ADDENDUM 04

Date: March 17, 2022

Project Name: Gregg County Parking Garage and Office

SHA Project No.: 20011

ENLARGED PLAN - PUBLIC RESTROOMS 2 SCALE: 1/4" = 1'-0" A2.8

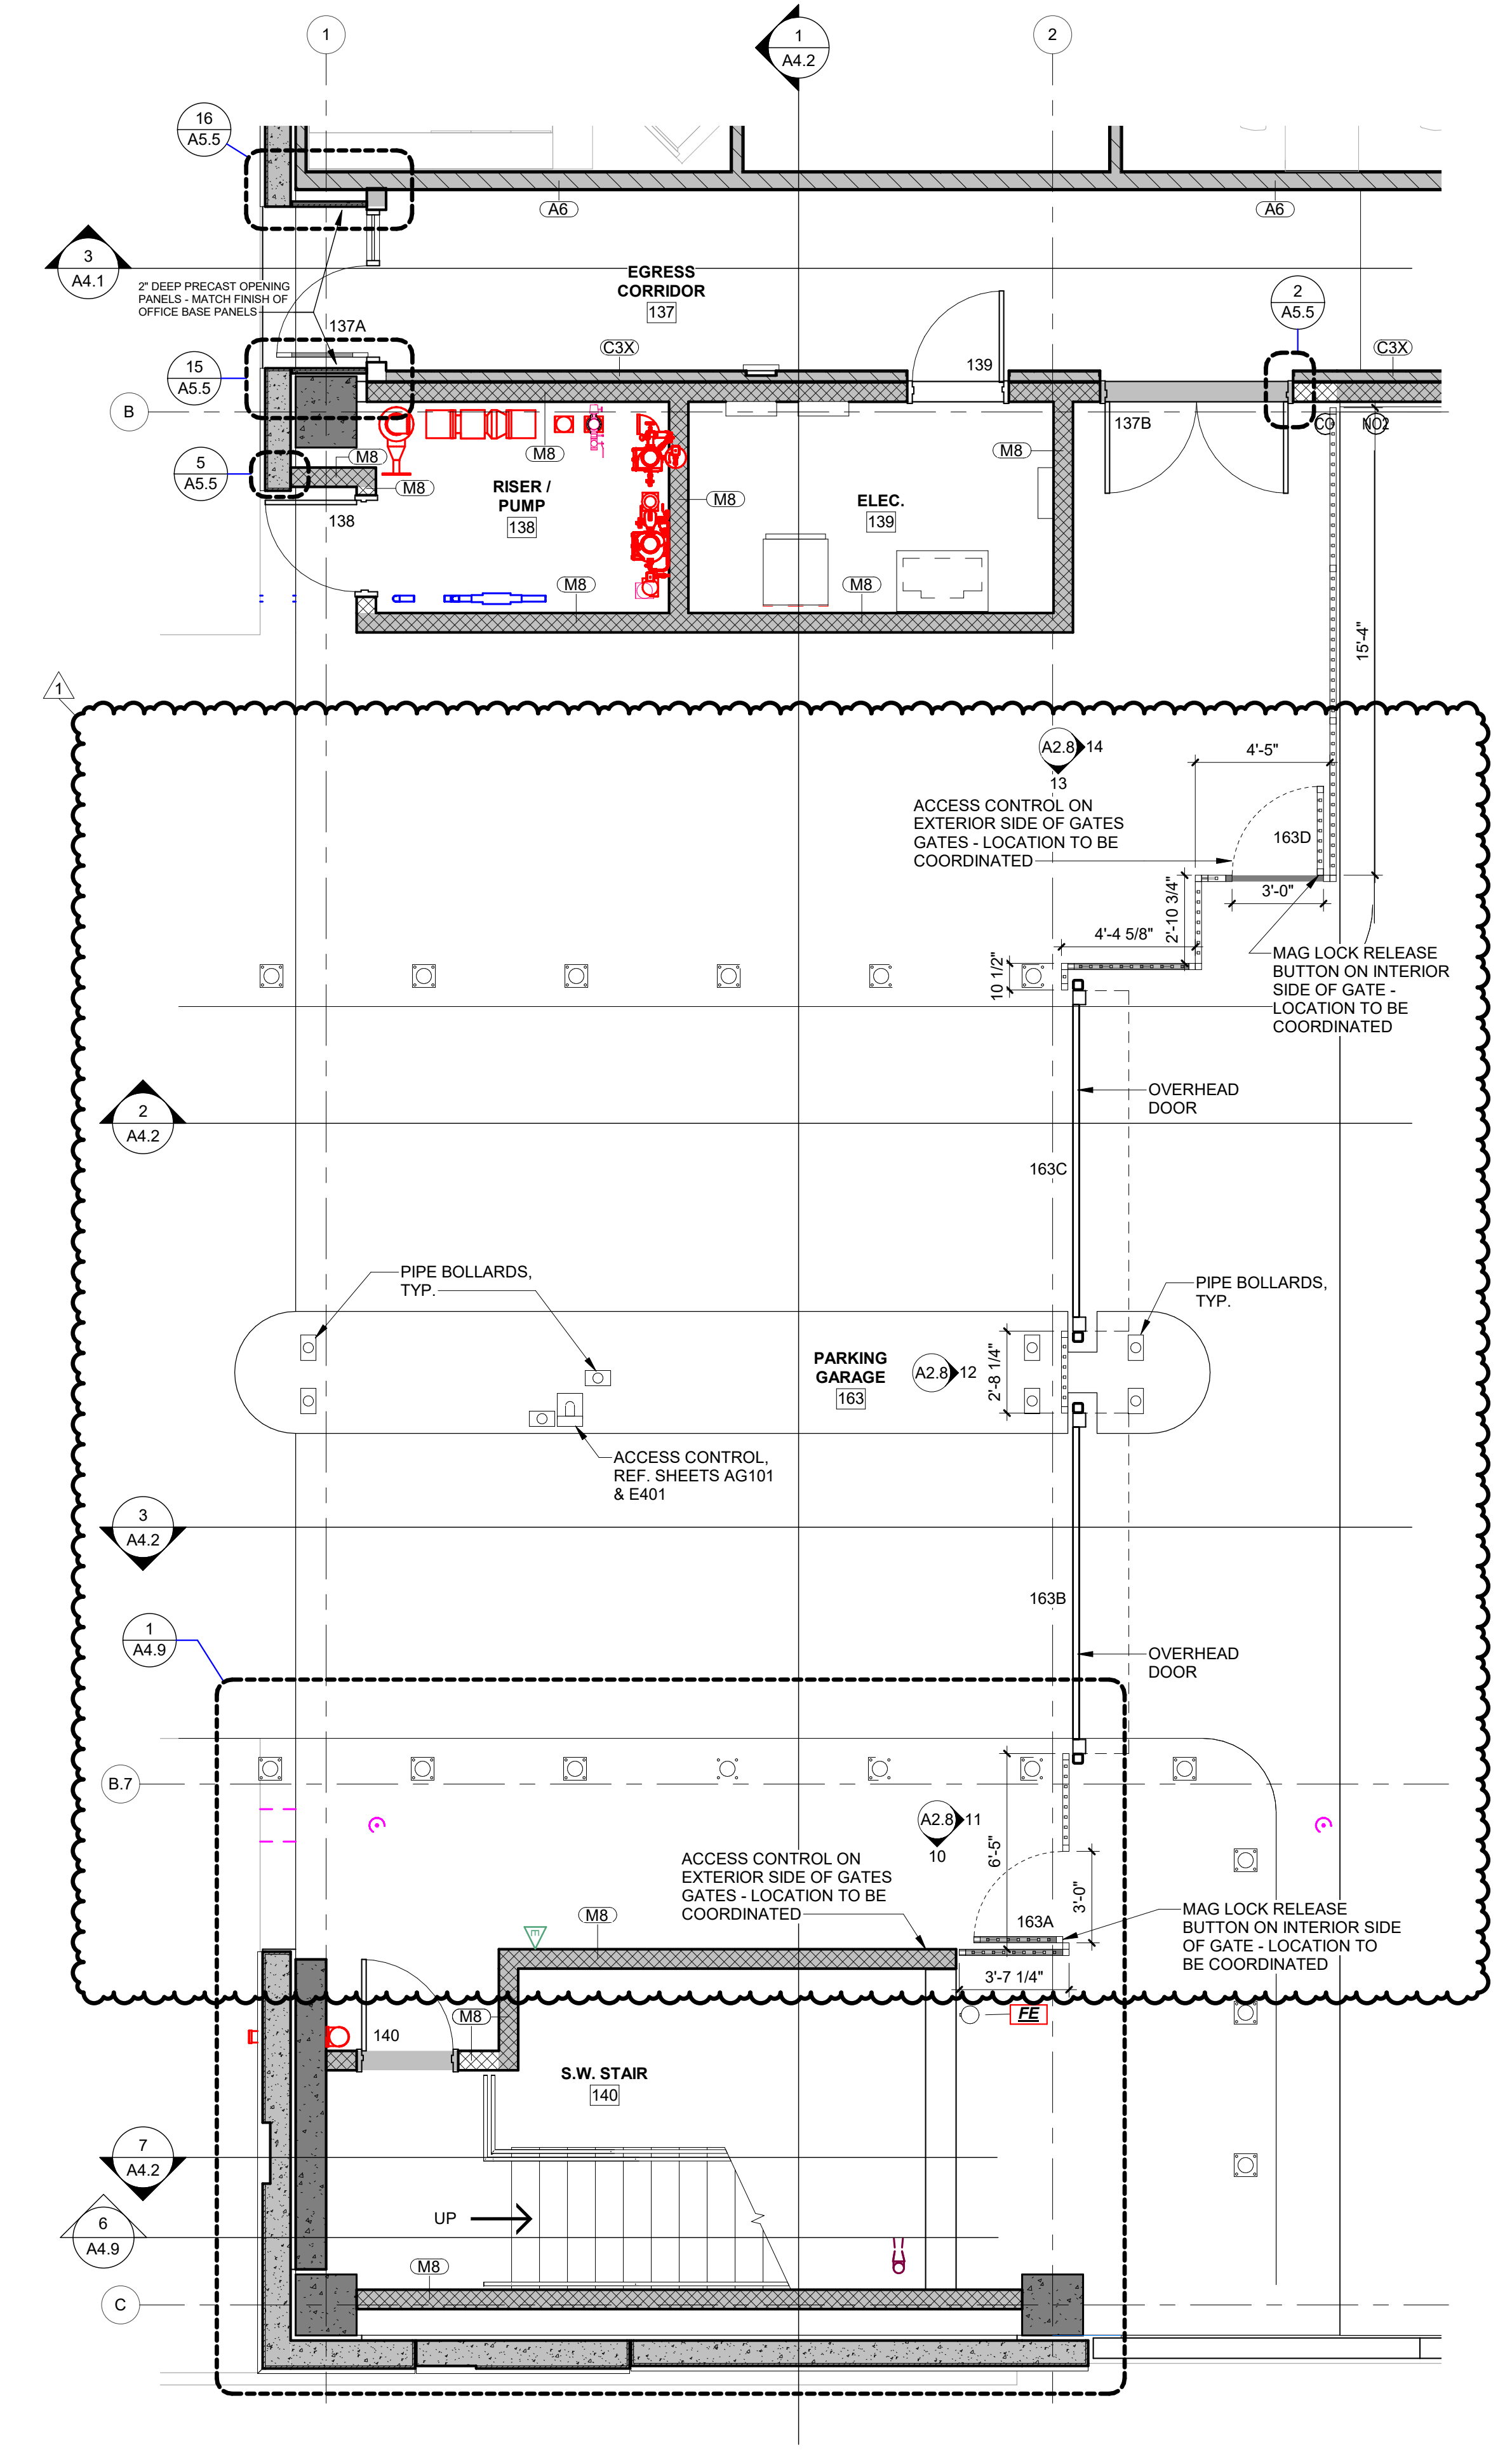
Question #A15: Please have the Architect provide more information for the clouded items on the attached garage entry plan.

Response #A15: Sheet A2.8 was revised to show more annotations regarding the clouded bollards and vehicle entry equipment. Also, refer to sheet(s) AG101, S101, & E401 for further clarification.

A3.1

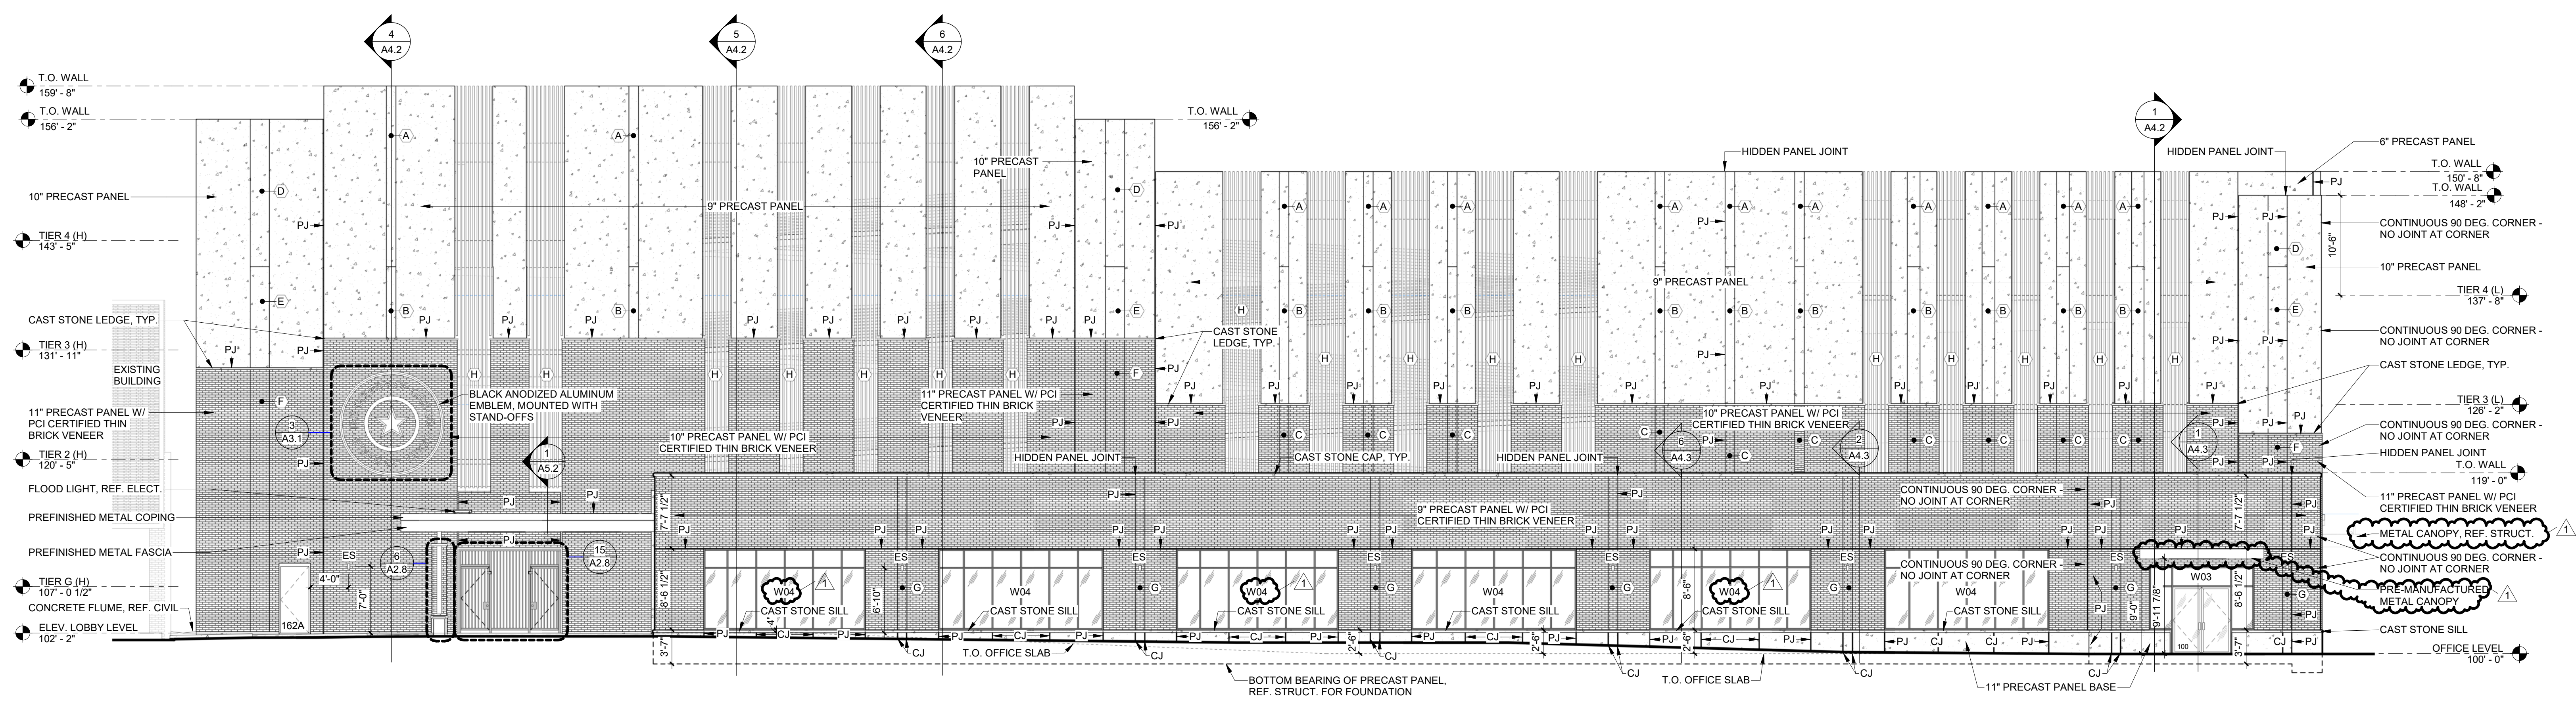
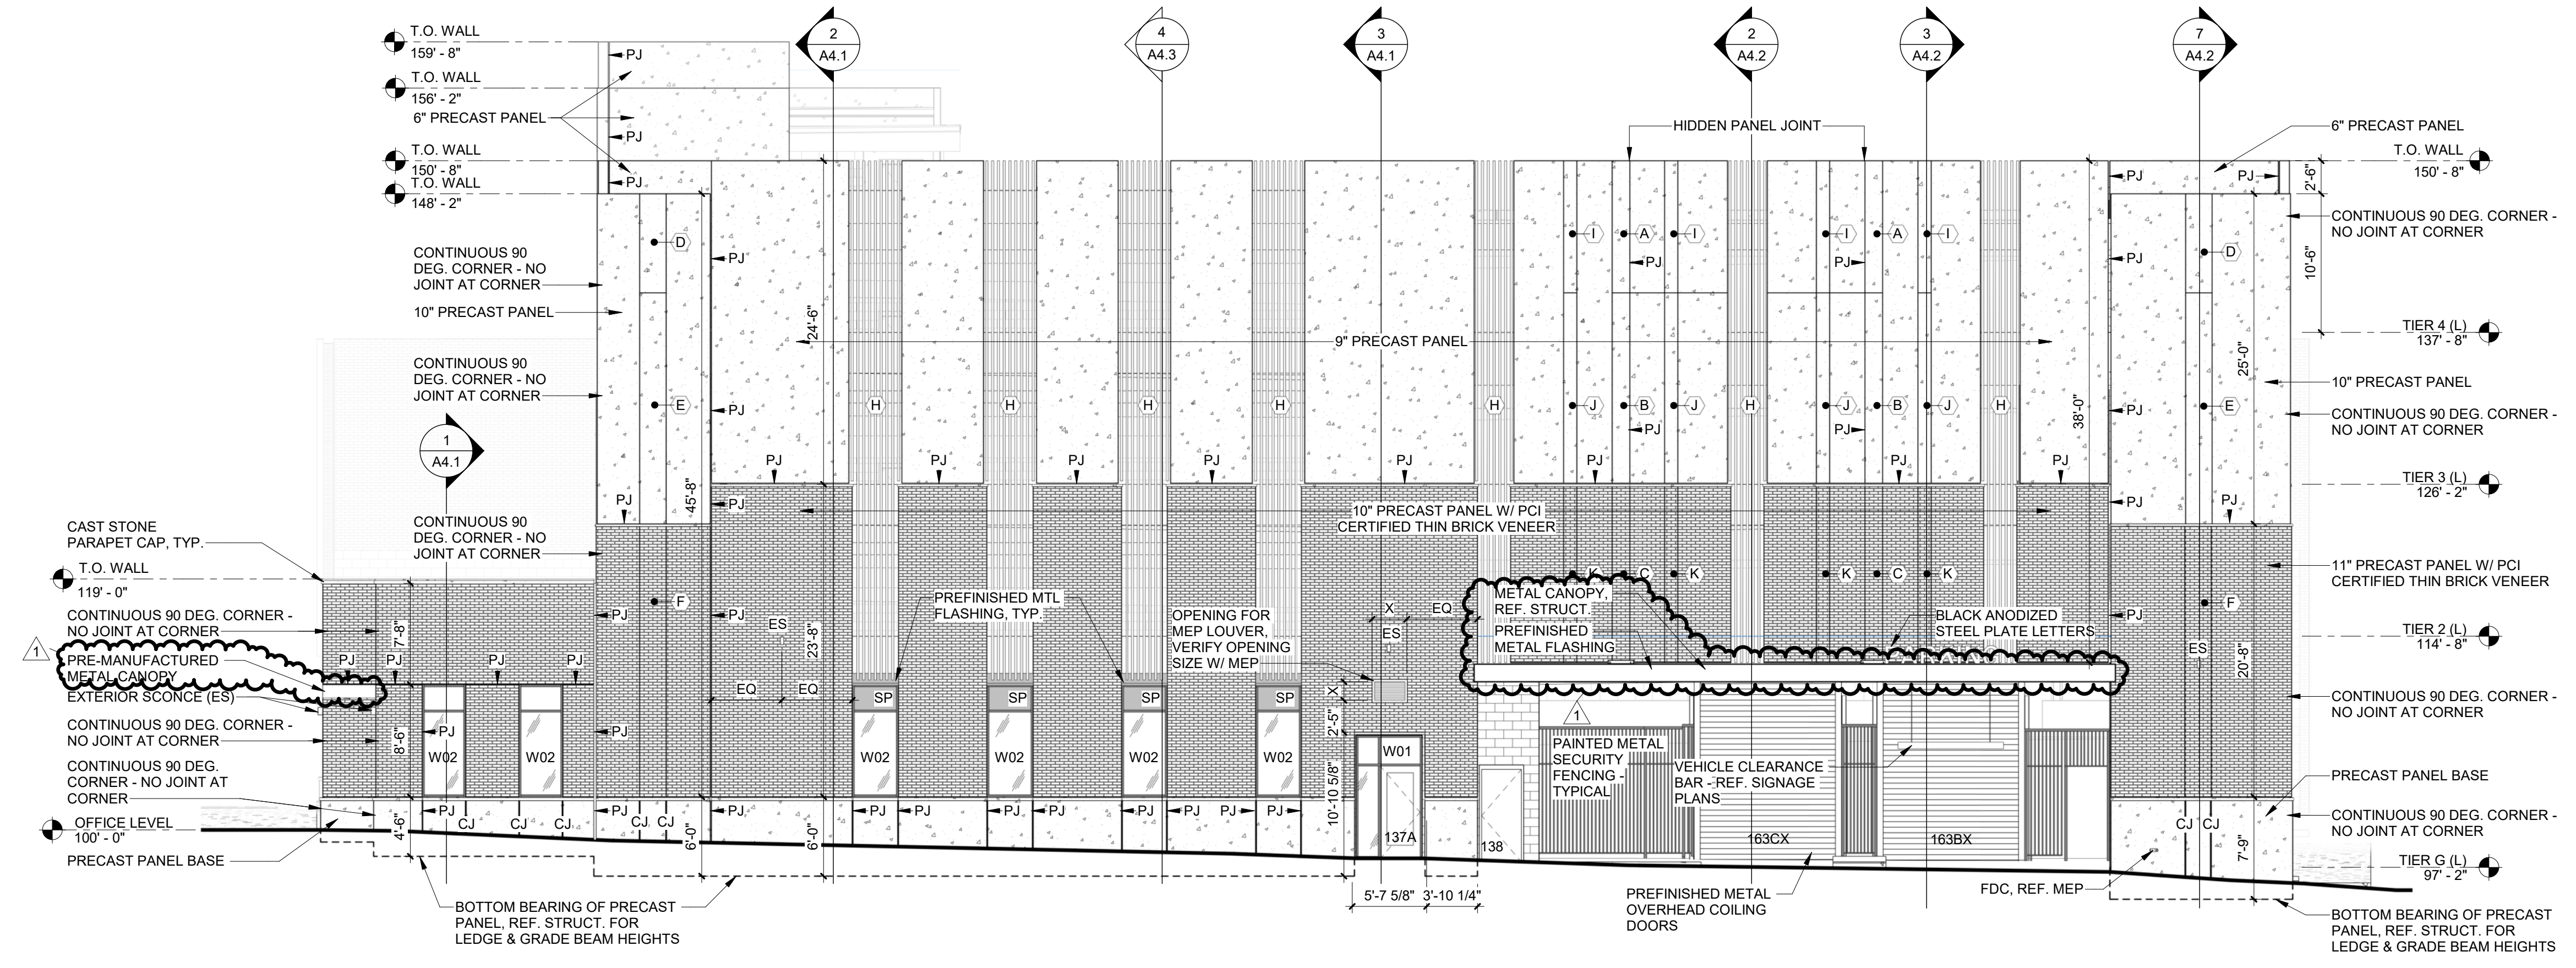
Question #A14: I do not see a specification section for the vertical aluminum louvers (note 'H' on sheet A3.1). Please clarify.

Question #A16: On the North elevation on sheet A3.1, three of the six large windows are indicated to be window type 'W05'; however, 'W05' shown on sheet A6.1 is simply a transom door frame. These same three windows are also incorrectly marked on enlarged plan sheets A2.6 and A2.7. Please clarify

Response #A14: Please refer Sheets A2.1-A2.5 for opening width dimensions. Please refer to Sheets A3.1-A3.2 for height dimensions and note 'H' which provides the design criteria the extruded aluminum tube (vertical fins) need to meet.

Response #A16: We revised sheet(s) A2.6, A2.7 & A3.1 to correct the storefronts in question to read type "W04".

WALL SECTION 10
 SCALE: 1/2" = 1'-0"
 A4.3

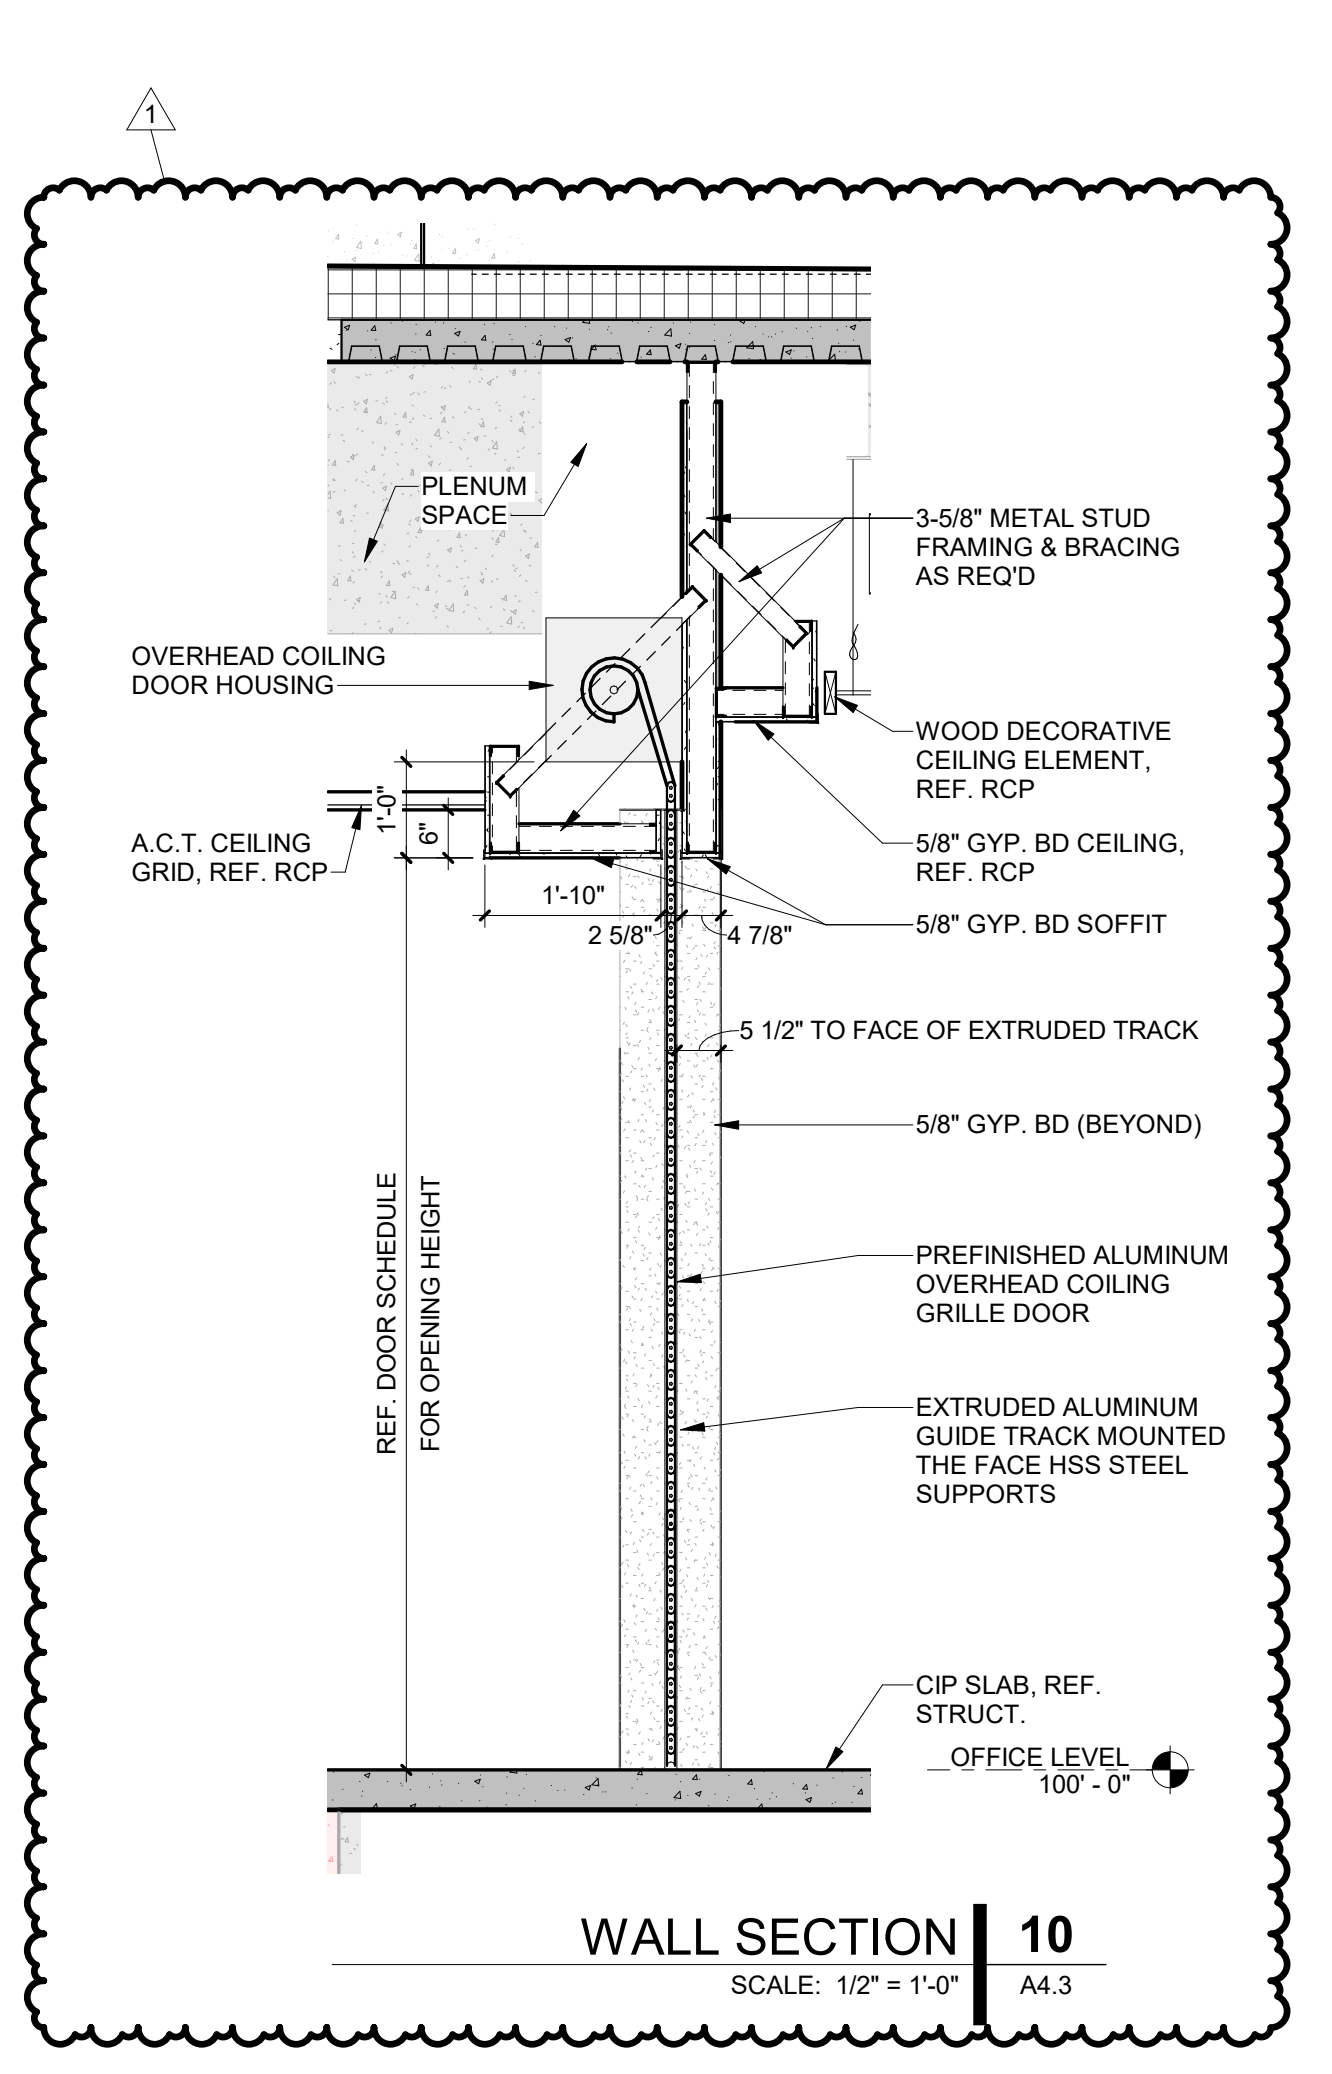
Question #A11: The plans show (2) security grilles in the Lobby/Retail area that are note on the door schedule. Can you provide door or opening sizes for these?

Response #A11: Sheets A2.1 & A2.6 have been revised to indicate the correct door type numbers and section detailing for these doors. The door elevations related to these two doors, on sheet A6.1, has been revised to read door type 'D8'. Additionally, wall section 10/A4.3 was added to the set.
